# Work Order ID 79713

Item Name: Replacement Skidtube

DRAWING NO. D2580  
REV. E  
SHEET 1 OF 8  
TITLE 205 SKIDTUBE ASSEMBLY  
SCALE NTS

DRAWING NO. D2580	TITLE 205 SKIDTUBE ASSEMBLY	REV. E	DART AEROSPACE LTD ENGINEERING ORDER		D.E.O. NO. D2580-E-1	SHEET NO. SHEET 1 OF 1	SCALE NTS
DRAWN <i>UP</i>	CHECKED <i>ASS</i>	MFG. APPR. <i>ER</i>	APPROVED <i>[Signature]</i>		DE APPR. <i>[Signature]</i>		
DATE 11.12.13	DATE 11.12.13	DATE 11.12.13	DATE 11.12.13		DATE 11.12.13

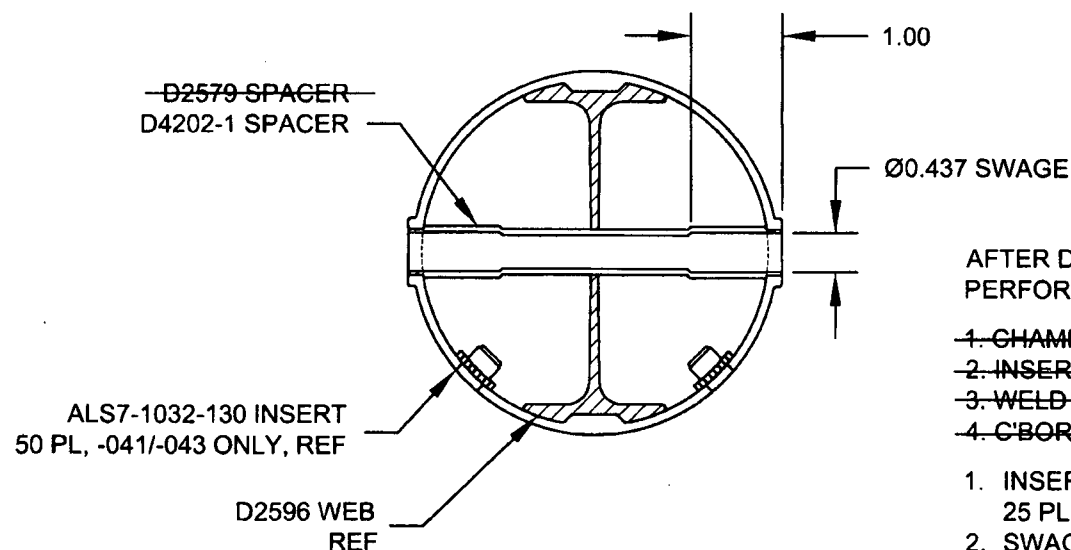
CHANGE ALL C'BORED WELDED CROSSBOLT SPACERS TO SWAGED SPACERS

**WAS**

QTY	QTY	QTY	PART NUMBER	DESCRIPTION
-041	-045	-047		
20	24	25	D2579	CROSS BOLT SPACER

**IS**

4		* D2579	CROSS BOLT SPACER
20	20	25	D4202-1	SPACER

**\* FOR -045 SKIDTUBE ONLY:**  
WELD 4X D2579 SPACERS PER DWG  
IN LOCATIONS MARKED "NO C'BORE".  
REF SHEET 4 OF DWG.
